RECEIPT DATE: 2/16/23 **ONSITE SEWAGE DISPOSAL SYSTEM**

PROPERTY ADDRESS: 625 Weller Drive

ON SITE SEWAGE DISPOSAL SYSTEM DESIGN PLAN
LOT 16
PATAPSCO OVERLOOK
PLAT No. 6783
625 WELDER DRIVE

From: Silvast, Zackary <zsilvast@howardcountymd.gov>
Sent: Tuesday, August 23, 2022 12:42 PM
To: Ron Thompson <ron@vanmar.com>
Cc: Williams, Jeffrey <jewilliams@howardcountymd.gov>
Subject: regarding OSDS plan for 625 Weller Drive

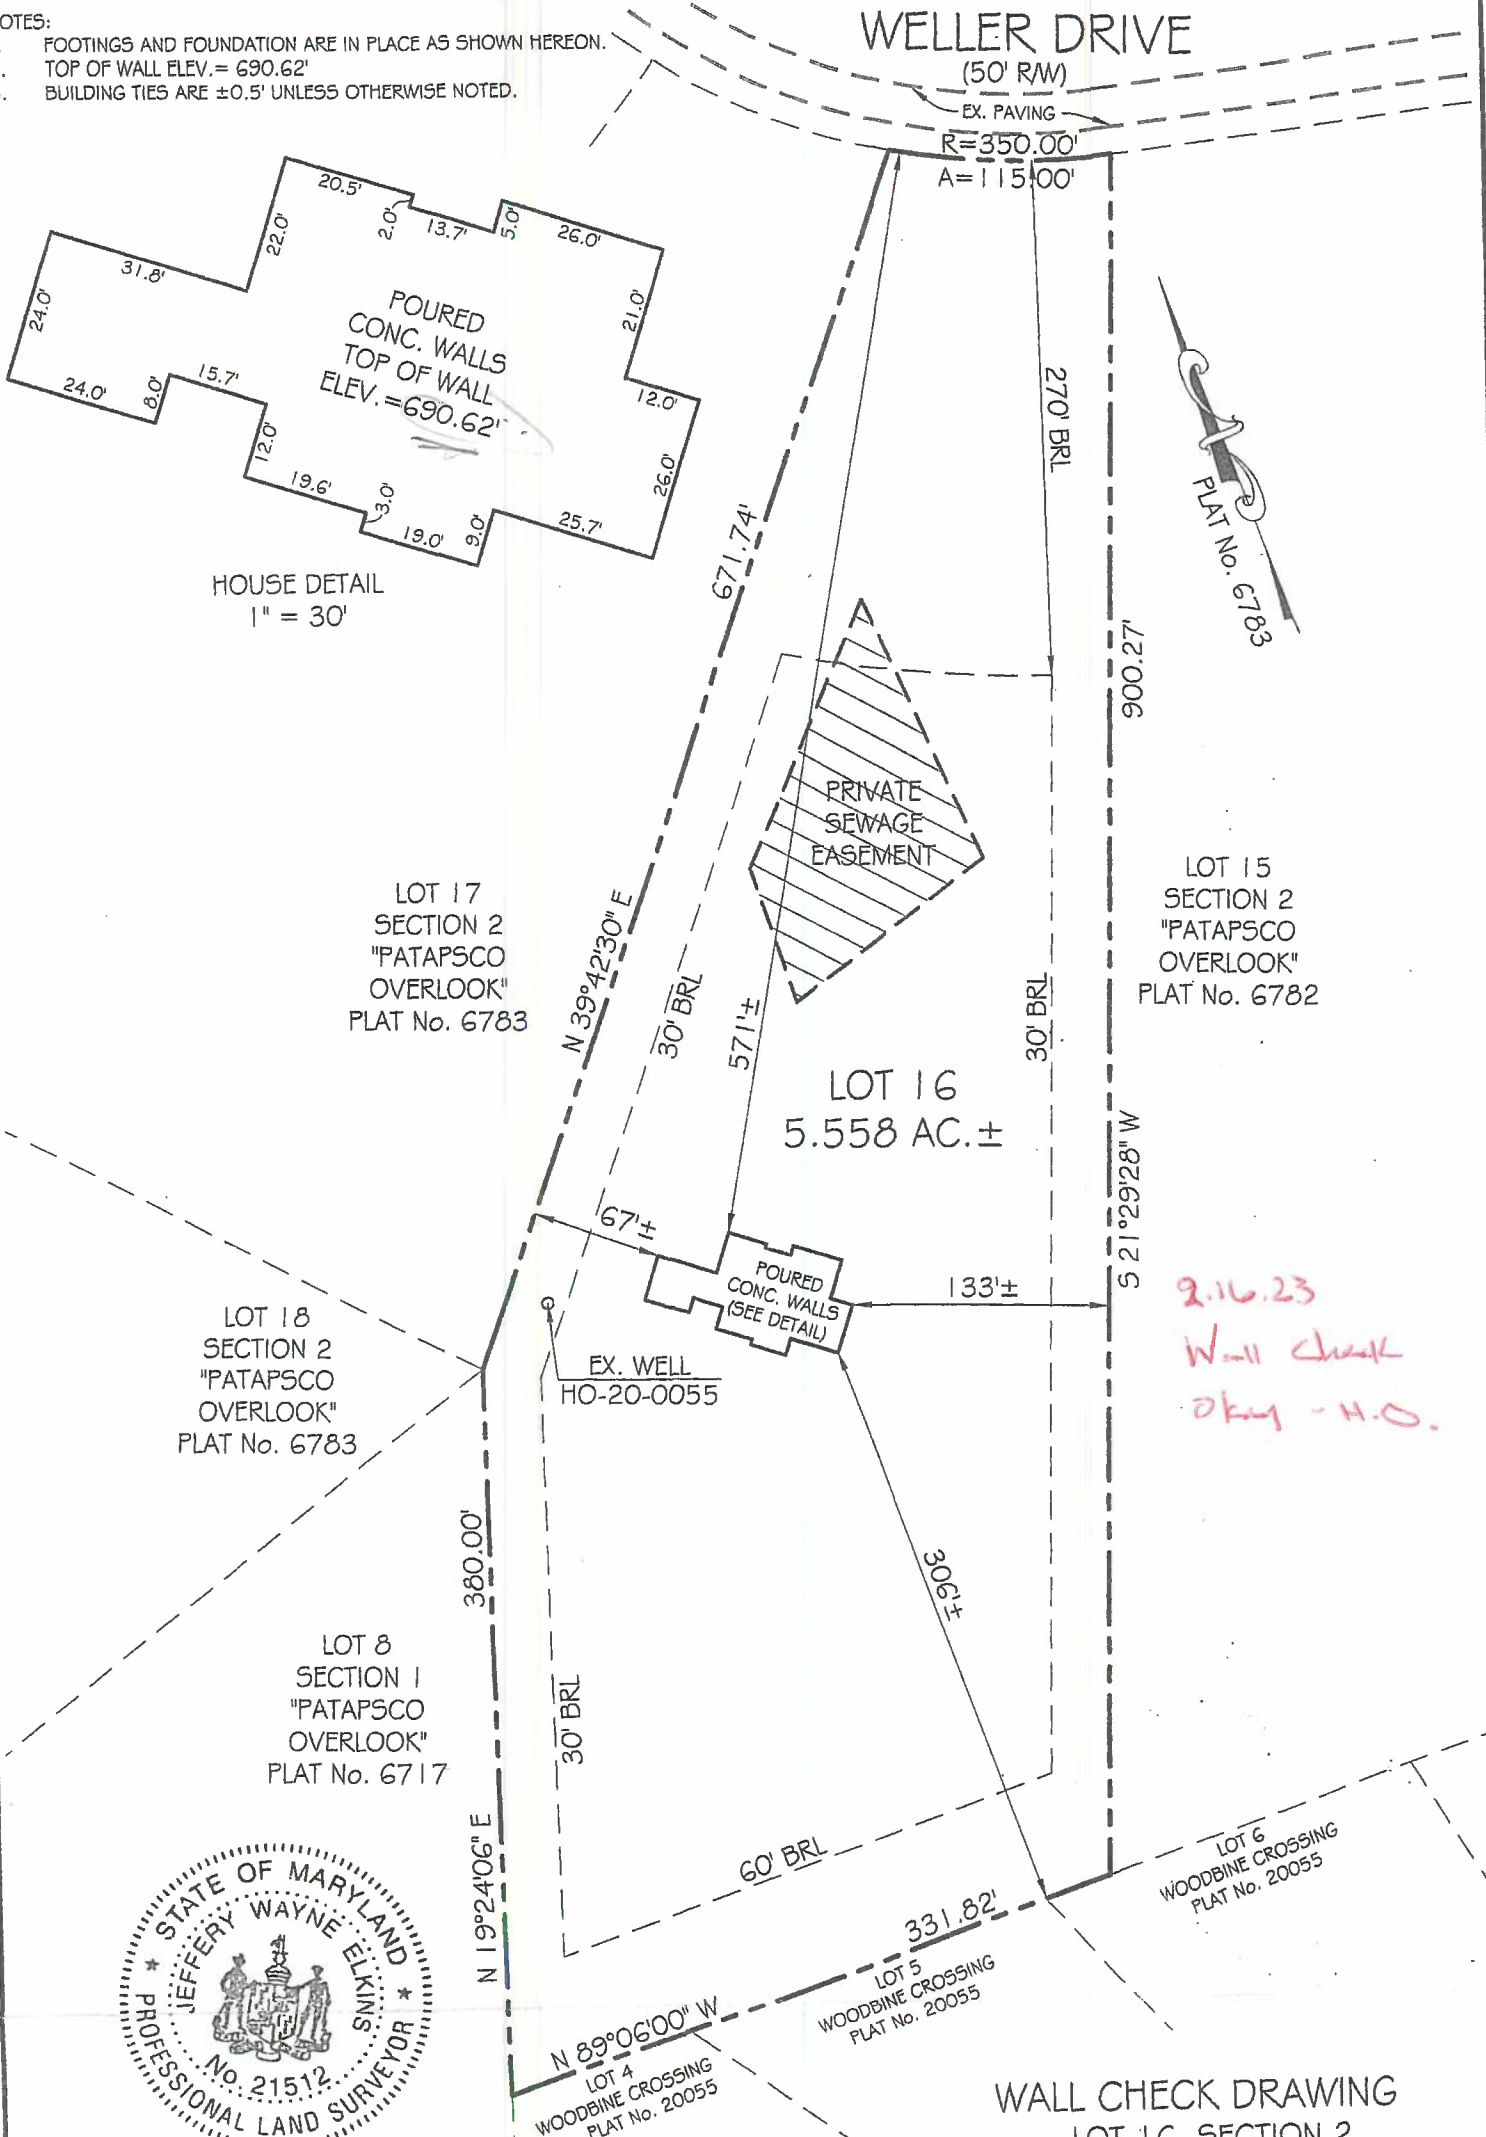
3/8/23 - laid out 3x63' trenches on contour, contractor confirmed minimum fall of 1% will be achieved for sewer line to tank & dbox. Should be alright on fall for Trench 1, Trench 2/3 - no problem w/ fall. OK to continue w/ install. (RP)

INSTALLATION: 3/9/23 - site inspection, contractor on site, most of the work has been completed, working on last trench during site visit, tank installed, fall to tank & trenches ok, attempted to level the dbox but the hole for T2 pvc is leaking, trenches look good, stone not great but acceptable, requested that contractor use a quarry that does a better job w/ washing the stone, geotextile fabric in place & soil looks really good at trenches - can't read the perc notes to compare soils to perc #5 & 8, reinspect for dbox (RP) 3/10/23 - dbox repaired and leveled w/ levelers, no leaking observed. OK to continue & backfill. (RP) 3/14/23 - qps'd well & as built well, stc confirmed (sewer line under footer). (RP)

ON SITE SEWAGE DISPOSAL SYSTEM DESIGN PLAN
LOT 16
PATAPSCO OVERLOOK
PLAT No. 6783
625 WELLER DRIVE

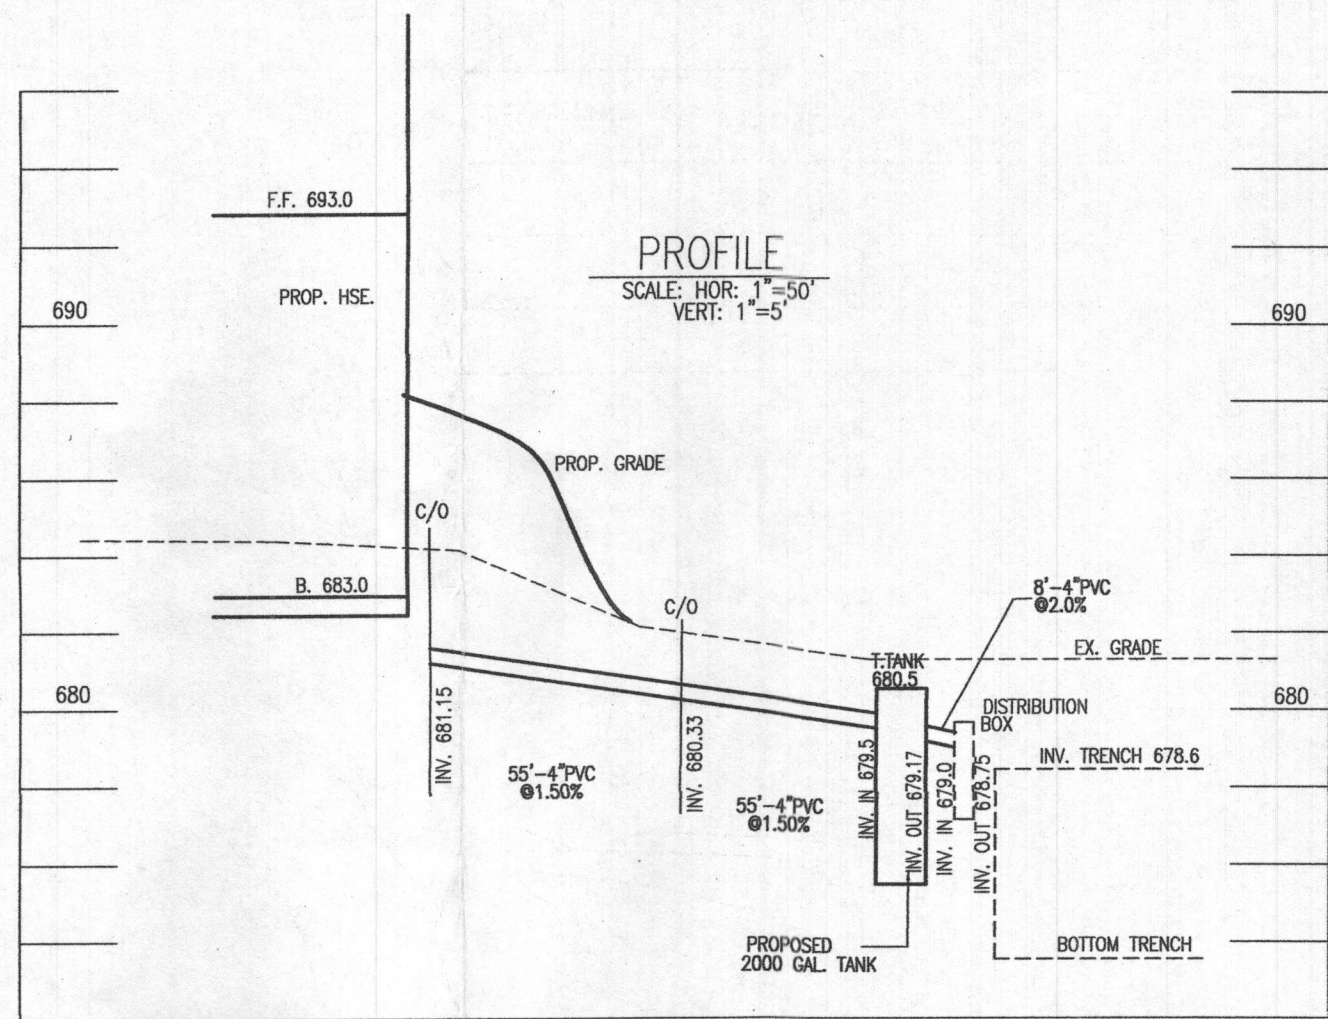
1. **I'm asking that 10' separation from all septic trench lines be shown. The trench layout can be altered/shifted slightly so that the trenches are more aligned with one another while still holding the contour lines. Thus they can be positioned a certain way in the SDA where all the lines maintain minimum 10' separation and they are aligned and straight.** There is a 10 ft separation between all the trenches. Trenches are straight and aligned with the contours
2. **Label tank on site plan as "2,000 GAL septic tank"** Labeled as '2000 gal septic tank'
3. **Label "existing 10,000 sf SDA" on site plan.** 'Ex 10,000 SF SDA' labeled.
4. **Label "neighboring existing SDAs"** labeled

1. I'm asking that 10' separation from all septic trench lines be shown. The trench layout can be altered/shifted slightly so that the trenches are more aligned with one another while still holding the contour lines. Thus they can be positioned a certain way in the SDA where all the lines maintain minimum 10' separation and they are aligned and straight.
2. Label tank on site plan as "2,000 GAL septic tank"
3. Label "existing 10,000 sf SDA" on site plan.
4. Label "neighboring existing SDAs"
